UNITED STATES PATENT AND TRADEMARK OFFICE

APPLICATION NO.	FILING DATE	FIRST NAMED INVENTOR	ATTORNEY DOCKET NO.	CONFIRMATION NO.
10/075,216	02/14/2002	Michael Alois Kolowski	DN2002024	7021

Office Action Summary

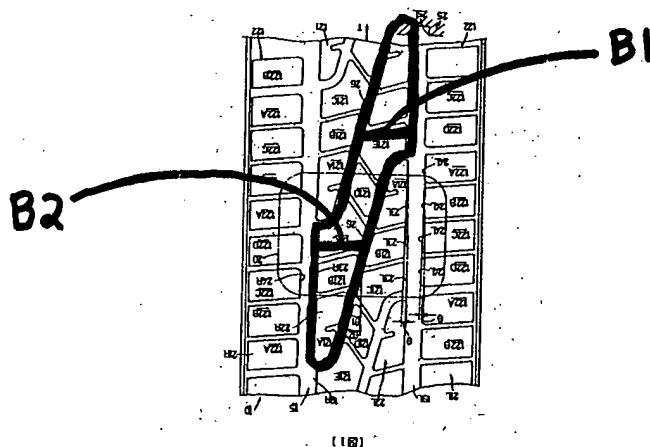
The claimed tread reads on the tread having the tread pattern shown in figure 1. The claimed central array reads on the "central array" comprising seven blocks 121A, 121B, 121C, 121D, 121E, etc. Japan '207 teaches delimiting the central array using slant grooves 26 and portions of grooves 19L, 19R. The slant grooves have oppositely curved end sections. The slant grooves 26 are inclined at an angle of 1-15 degrees with respect to the circumferential direction and the portions of grooves 19L, 19R are slightly inclined at an angle of for example 2 degrees. Figure 1 of Japan '207 is reproduced below with markings added by the examiner:

The markings added by the examiner indicate one of the central arrays of tread elements and shows example boundaries B1 and B2 of a "midsection" of the array. As to claim 17, the arrays overlap. For example block 121A (a block at the end of one

array) is adjacent a block 121D (a middle block of another array). As to claim 29, Japan '207's teaching to taper the blocks adjacent grooves 19L, 19R at 2 degrees forms a shoulder groove as claimed.

As to each array widening continuously from the first and second ends to the array midsection / the relatively wider midsection, claims 17 and 29 continue to read on Japan 207's array and fail to require an extent of widening at each end of the array longer than that shown by Japan 207 in figure 1. The term "midsection" (which is not defined in claims 17, 29 or the original disclosure) is sufficiently broad to read on a section of Japan 207's array comprising block 121D and at least a portion of blocks 121C and 121E. As can be seen from Japan 207's figure 1, Japan 207's array continuously widens from the end of block 121A to the middle of block 121C. The subject matter of "widening continuously" is describing *the array width between* the end and the midsection instead *of the array width of* the midsection. Claims 17 and 29 fail to require either a portion of or the entirety of the midsection to be wider than the section of the array between the midsection and either end of the array. The above noted marked up copy of Japan 207 indicates an example of the boundaries of a midsection. See lines B1 and B2. The width of the midsection at lines B1 and B2 is "relatively wide" because it is wider than the width of the slant groove 26 or block 121A. The array continuously widens from one end of the array to boundary B1 and from the other end of the array to boundary B2.
